Title:           Advisory Committee on Reactor Safeguards  
                  565th Meeting

Date:                Thursday, September 10, 2009

Call to Order and Welcome .....	4
Indian Point License Renewal .....	7
Briefing/Discussion with NRC Staff .....	83
Entergy Response to Questions .....	94
Public Comments .....	113
License Renewal Application .....	117
and Final SER for the Three Mile Island	
Nuclear Station Unit 1	
Briefing/Discussion with NRC Staff .....	118
Fire Protection for Nuclear Powerplants .....	175
Draft Digital Instrumentation and	
Control Research Plan for	
Fiscal Years 2010 to 2014 .....	211
Adjourn

# ILRT Results

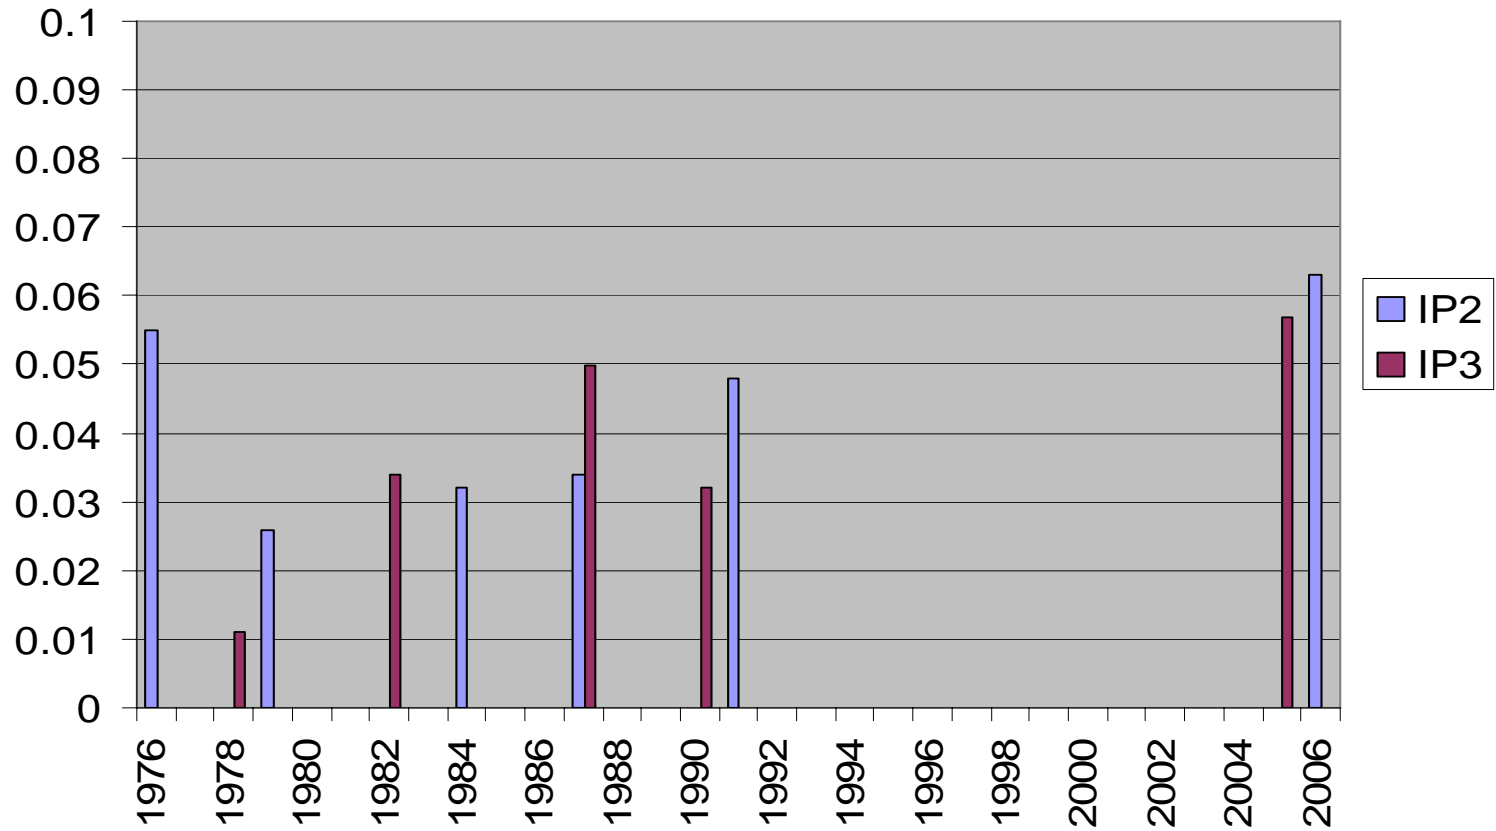
13 When you look at your graph -- maybe I ought to put  
14 my glasses on first -- it appears that the 2006 data  
15 for both plants is higher than all the preceding data,  
16 and not by an insignificant amount. It is almost --  
17 I'm just trying to do the eyeball check -- like .62  
18 versus .55, which is about 10 percent change for IP2,  
19 and for IP3 about 15 percent, it looks like,  
20 something.

22 MEMBER BROWN: Well, you made the  
23 statement, and there is no integrity question here.  
24 It is just looking at this; it is all below the .075,  
25 but, in fact, if I looked at this chart, I would say,

- Past ILRT results all below requirement of 0.075% of free volume per day.
- No unexplained changes in ILRT leak rates.

# IP2 Refueling Cavity

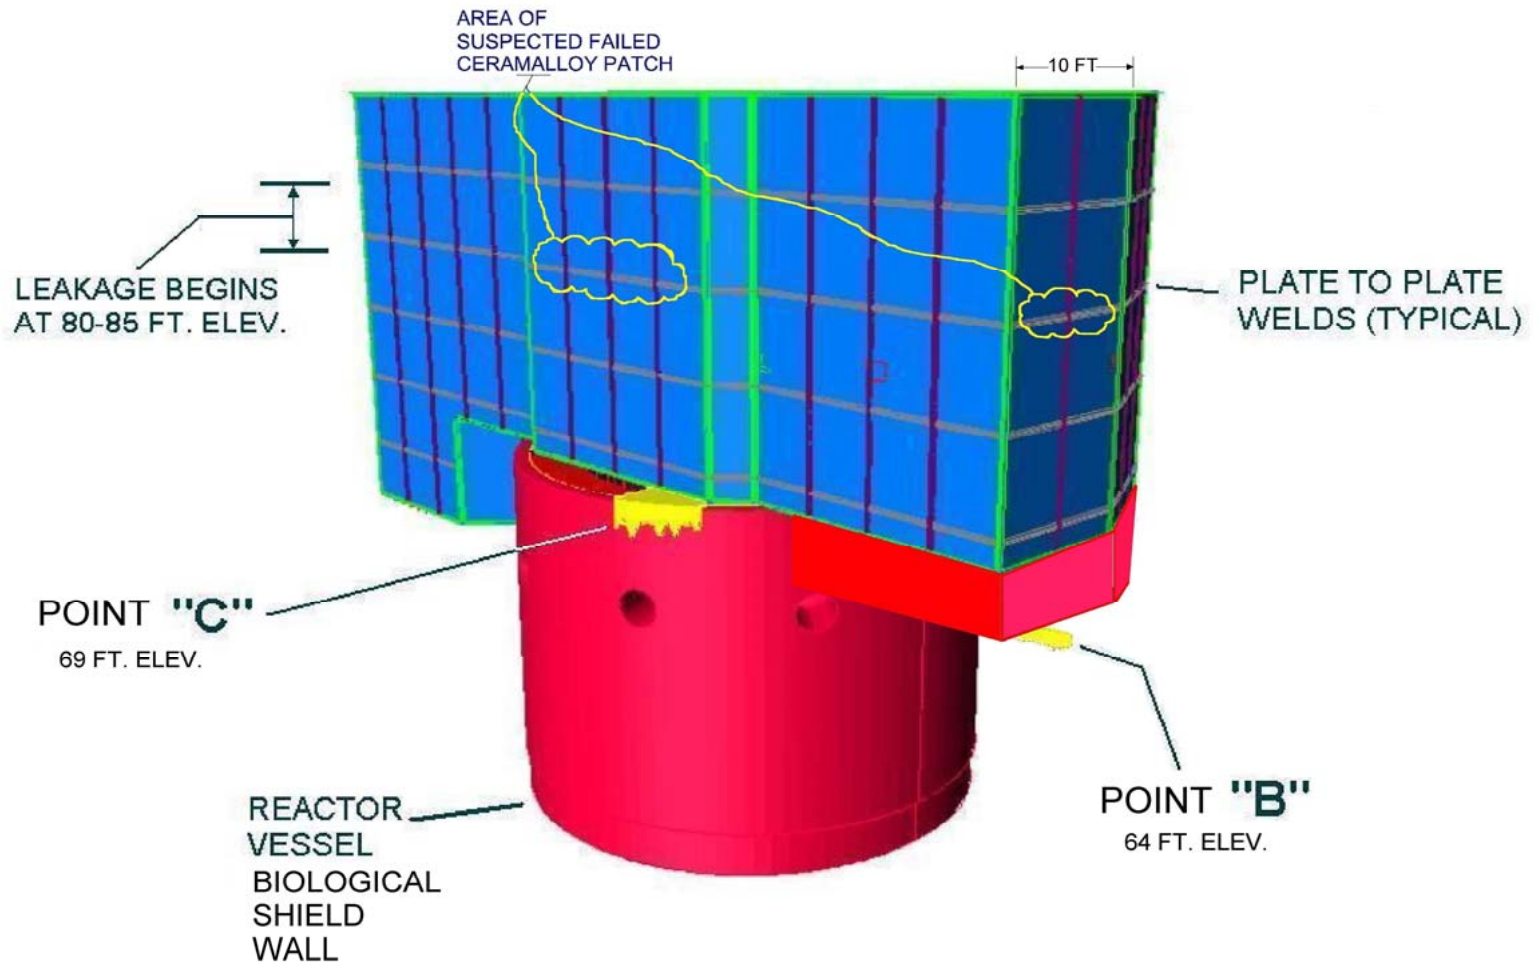
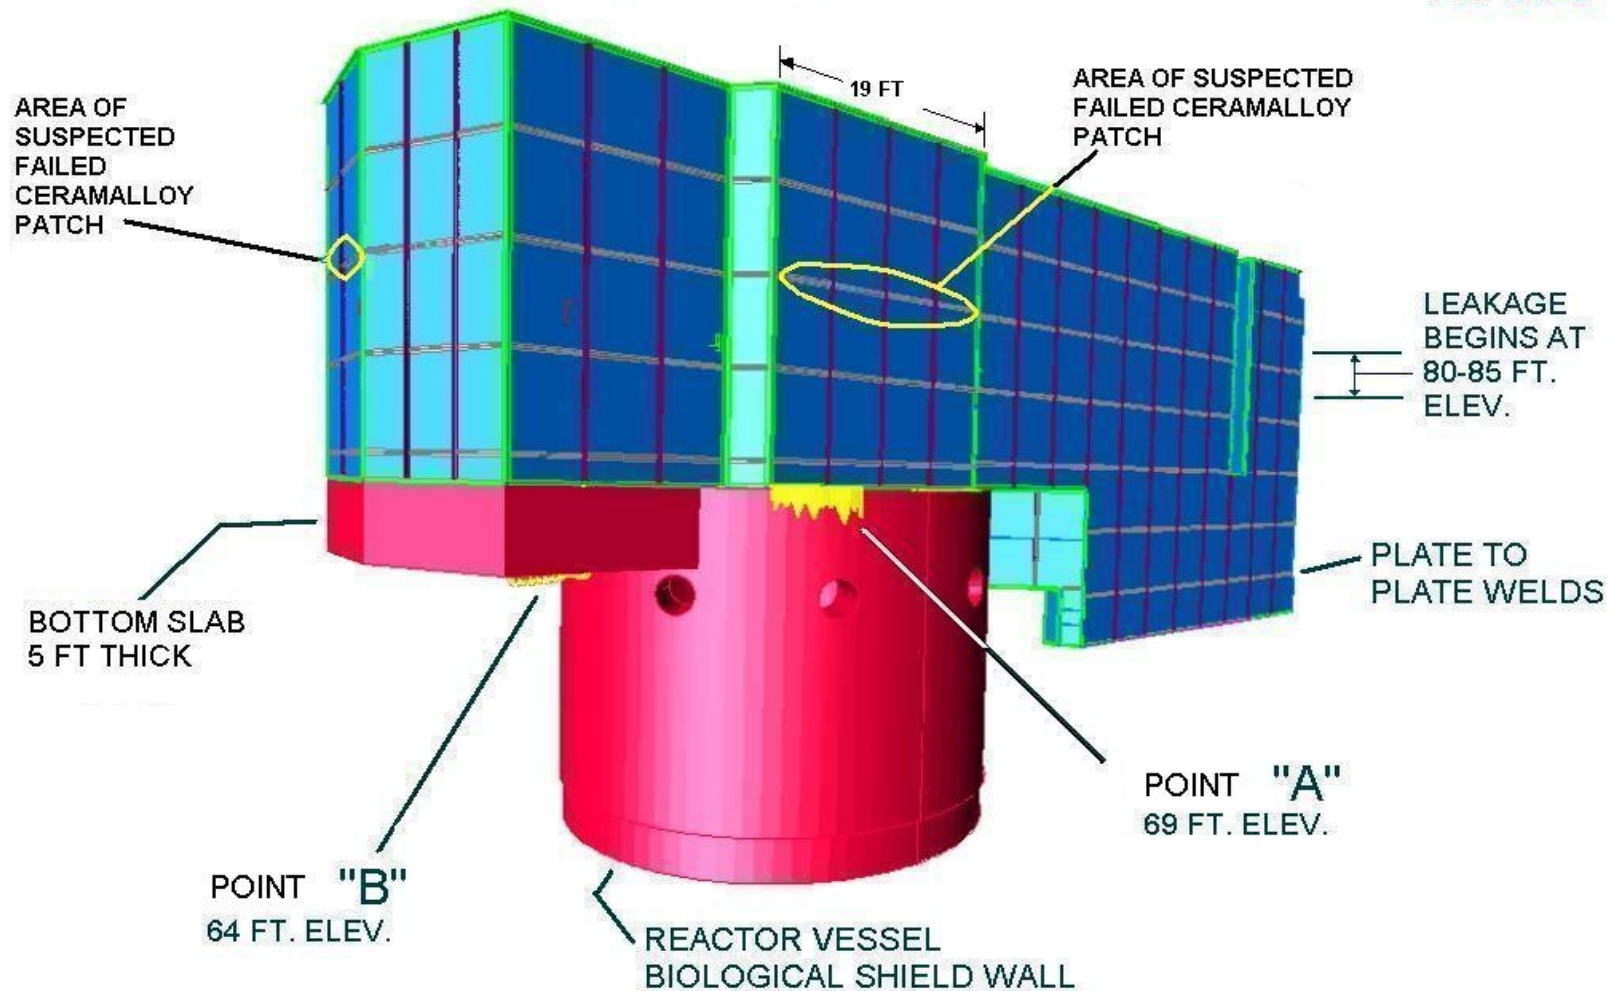
15 The leak location, the refueling cavity  
16 begins to leak when the cavity has been filled to the  
17 80-foot to 85-foot elevation, which is approximately  
18 midway up the cavity liner. It is a mid-weld. I will  
19 show that to you shortly.

ACRS requested information about the safety significance of the leak and better figures to show the flow paths.

- The refueling cavity begins to leak when the cavity has been filled to between 80' and 85'.
- Leakage occurs from three primary areas.
- Leakage is collected in sump and pumped to liquid radwaste processing system

# IP2 Spent Fuel Pool Leak

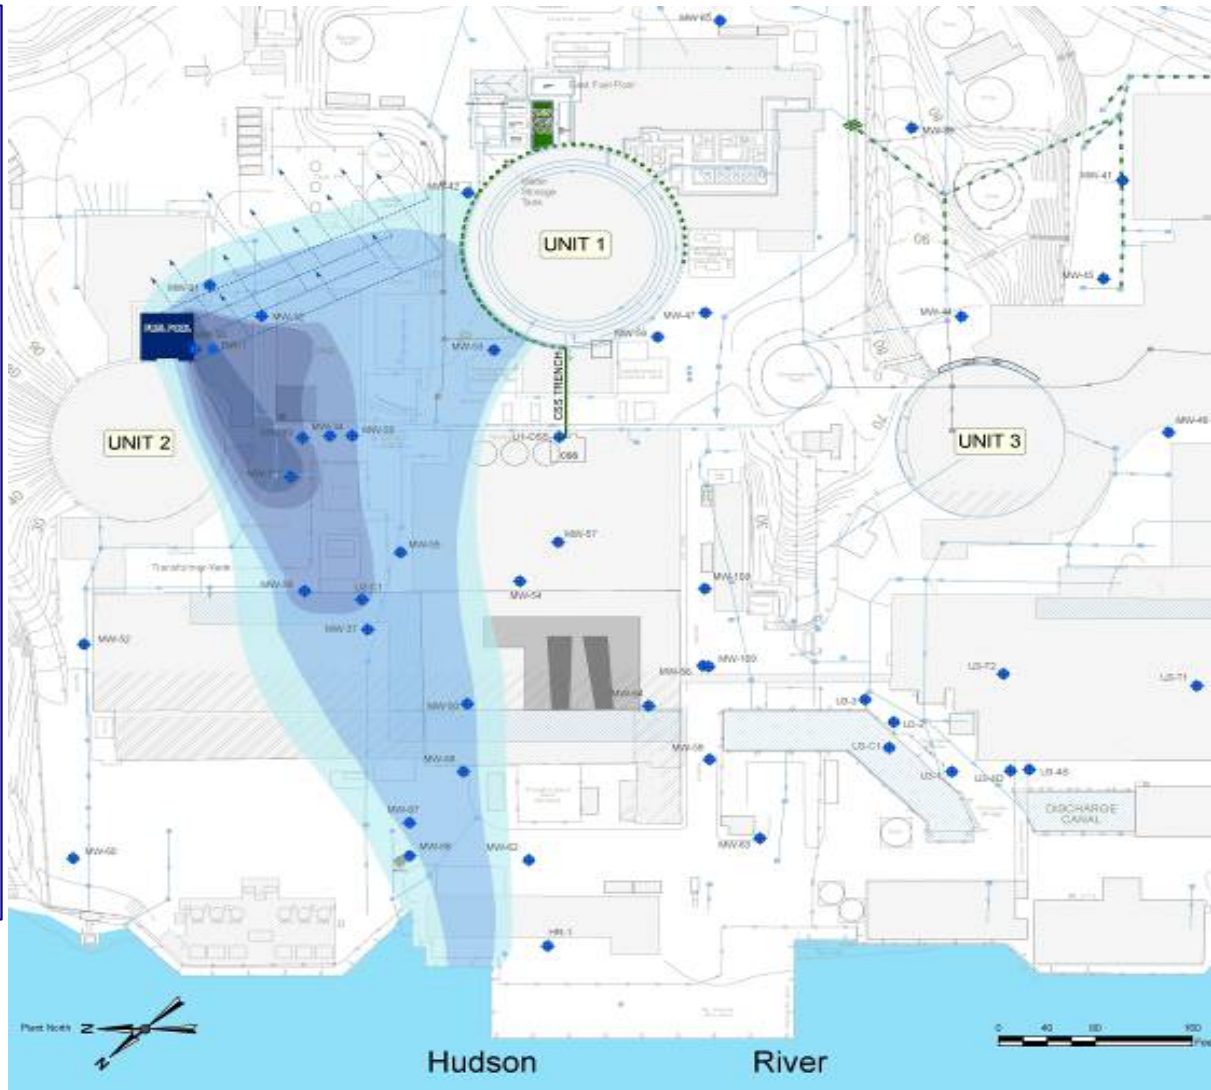
6 MEMBER BANERJEE: I have a question  
7 regarding the placement of your monitoring wells.  
8 This concentration profile that you show, the profiles  
9 you show there, there are significant high-  
10 concentration regions where there is no sampling,  
11 right?

12 So, if you look at, say, the second well  
13 to the right, it is near the surface, and then there  
14 are two wells after that which are fairly close to the  
15 surface, but the plume is going very deep. At least  
16 that's what your calculations show.

ACRS asked the applicant to bring more detailed hydrologic plume data for the IP2 spent fuel pool.

- Site conceptual hydrology model is robust and extensively documented.
- Over 40 monitoring wells, most of which are multi-level and range up to ~300' in depth
- Wells are configured with level transducers and sample ports for chemical/radiological sampling
- Plume characteristics and leak behavior understood in 3D space and time.
- Long-term monitoring program is institutionalized
  - Assess plume attenuation
  - Radiological dose assessment
  - Ongoing capability for detecting new leaks should they occur
  - **No tritium found in offsite wells.**

# IP2 Spent Fuel Pool Leak

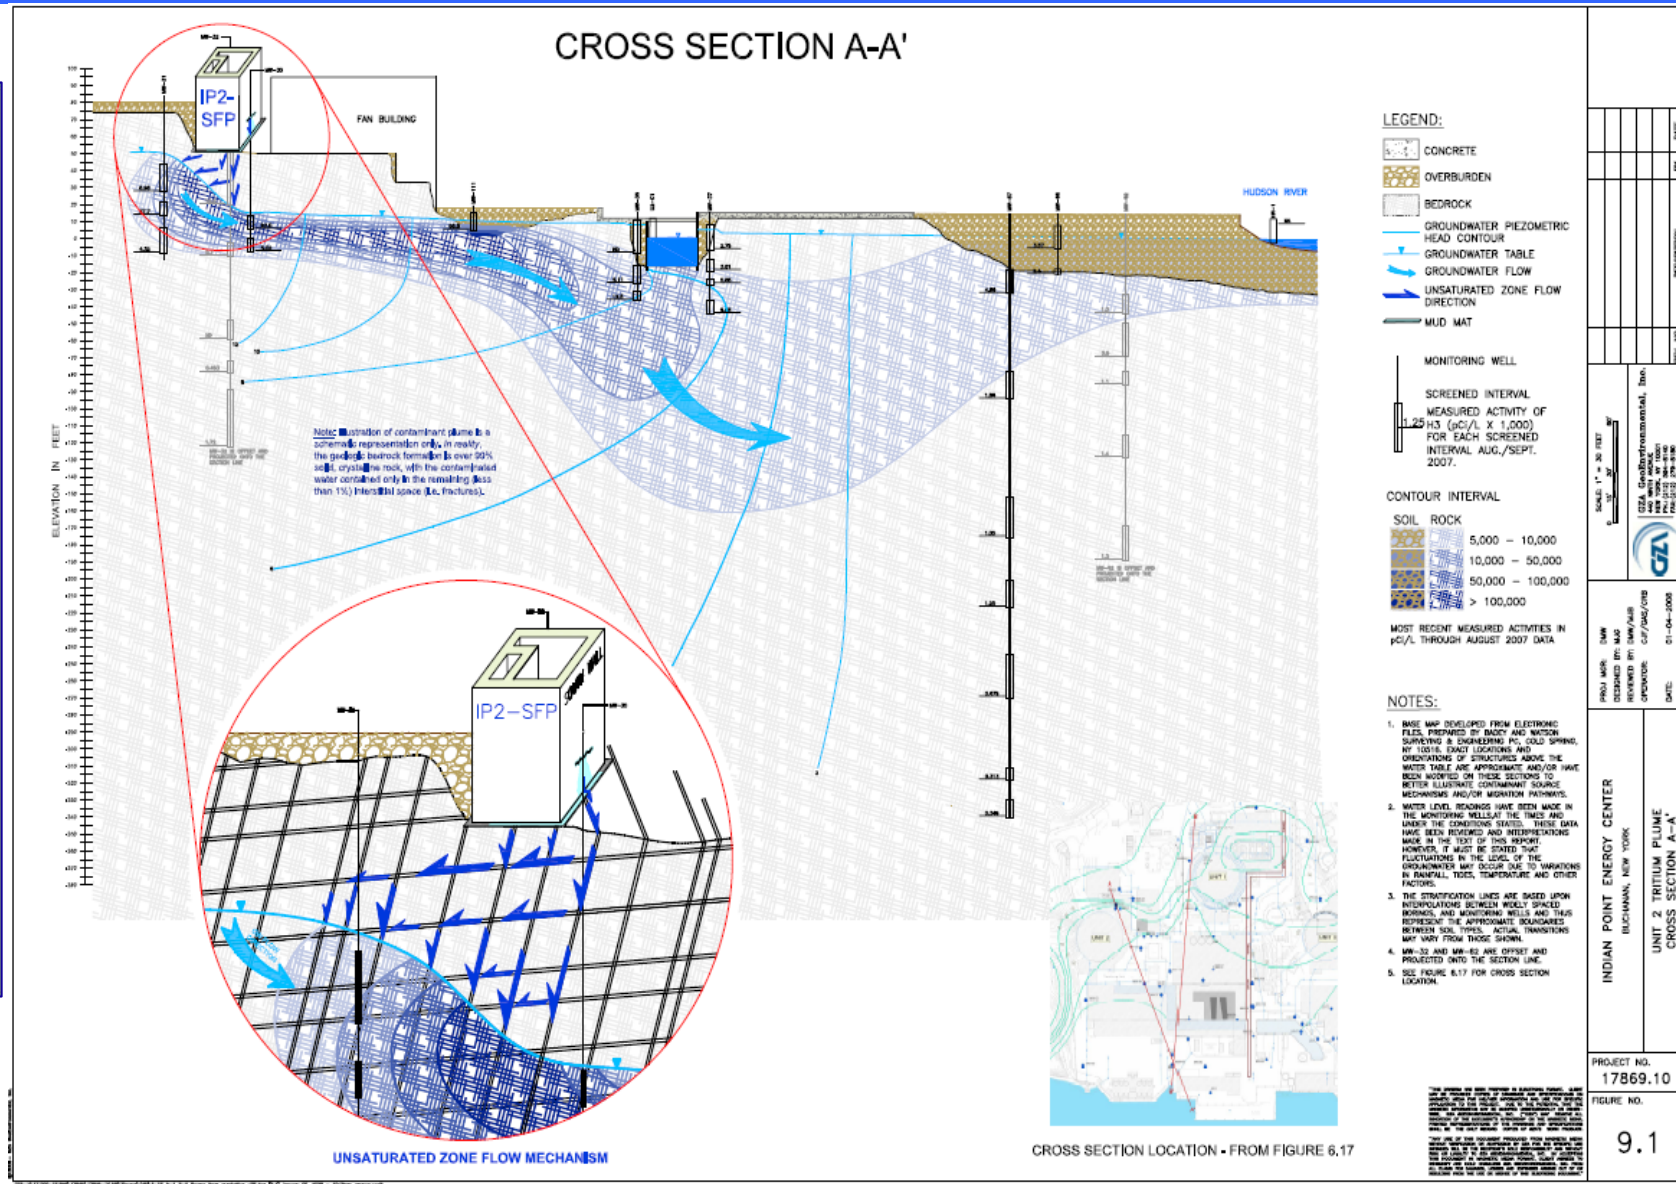
14 MEMBER RYAN: If I could just turn your  
15 attention to the figure that is up on the screen now,  
16 if I am reading the hash marks right, there is a 5 to  
17 10 thousand band that is fairly wide that seems to go  
18 across the river, is that right?

19 And what would you consider to be  
20 background in the groundwater without the tritium  
21 added?
